REMARKS

OBJECTIONS TO THE DRAWINGS

FIG. 3A

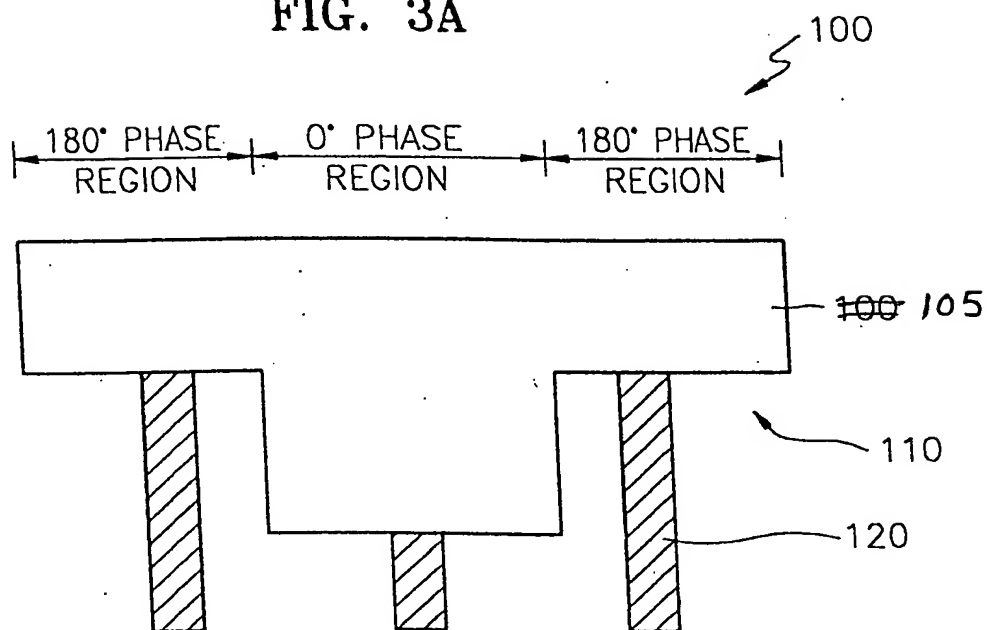
The objection that FIG. 3A should somehow be inverted is respectfully traversed, as Applicants are unaware of any rule which specifies a particular angle or viewpoint from which an object must be shown.

FIG. 4

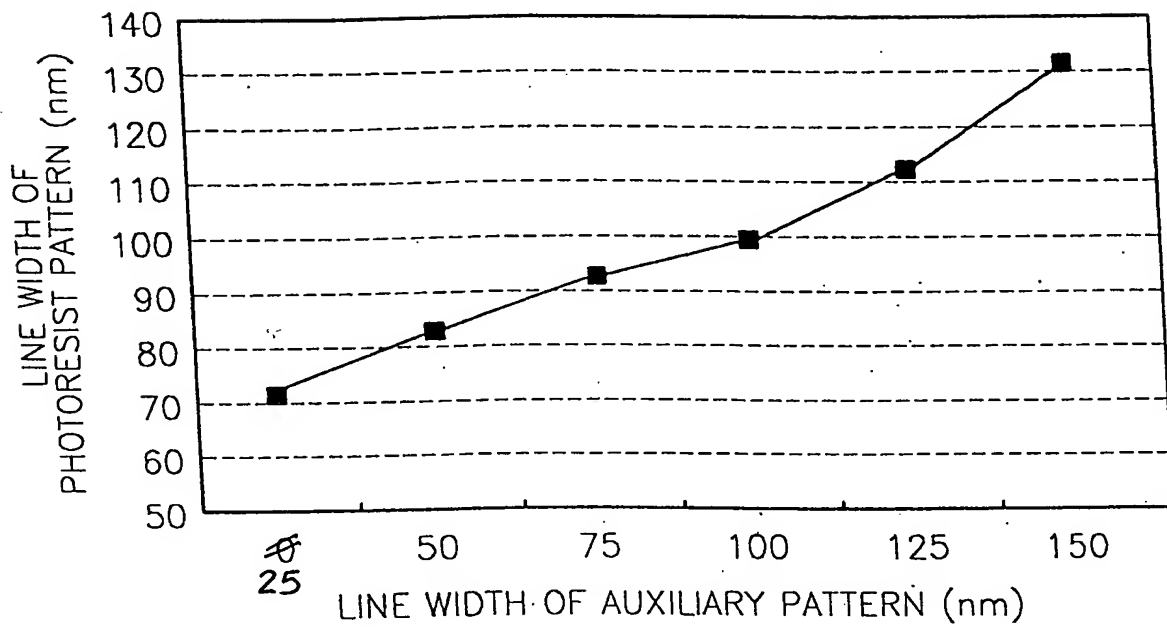
Applicants respectfully traverse the objections to FIG. 4 that: (1) FIG. 4 shows an apparently non-linear graph; and (2) FIG. 4 does not extend above 150 nm.

There is nothing that requires that FIG. 4 show a linear graph. The text in the specification cited by the Office Action is clearly permissive in nature ("may") as opposed to stating any exacting, rigorous requirement. Moreover, the graph in FIG. 4 actually does observe the stated relationship over the range of 25-125 nm. So FIG. 4 amplifies and expands upon the exemplary language in the specification, without being inconsistent therewith. Therefore, Applicants respectfully traverse this objection to FIG. 4.

Furthermore, there is no requirement that FIG. 4 plot any relationship for auxiliary pattern line widths above 150 nm. Indeed, the drawings would satisfy the requirements of 37 C.F.R. § 1.84(b) for claims 6 and 11 even if FIG. 4 was deleted in its entirety! That is, claims 6 and 11 include a feature pertaining to an auxiliary pattern, particularly, a line width of the auxiliary pattern. FIGs. 3A and 5C show the auxiliary pattern, including a line width of the auxiliary pattern, thereby satisfying the requirements of 37 C.F.R. § 1.84(b). Meanwhile, FIG. 4 does not show any auxiliary

pattern at all, and therefore certainly cannot possibly illustrate a line width of an auxiliary pattern! Instead, FIG. 4 shows a **graphical relationship** between a line width of an auxiliary pattern and a line width of a photoresist pattern. Now **if** claims 6 and 11 recited such a relationship, and if they recited that relationship over a range where the auxiliary pattern line width that exceeded 150nm, then the Examiner's objection **might** have merit. But that is not what is claimed here. Meanwhile, the features that actually *are* recited in claims 6 and 11 are shown in FIGs. 3A and 5C. Therefore, Applicants also respectfully traverse this objection to FIG. 4.

FIG. 5A

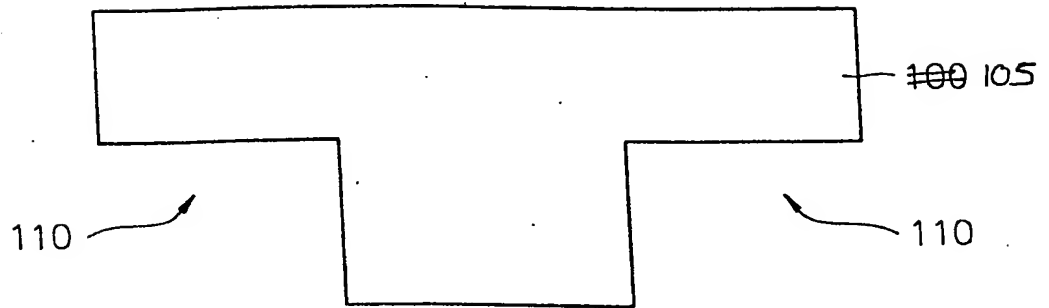
Please find attached to this paper, new drawings for FIGs. 1a-d, FIG. 3A, FIG. 4, and FIGS. 5A-5C, correcting minor informalities noted by the Examiner.
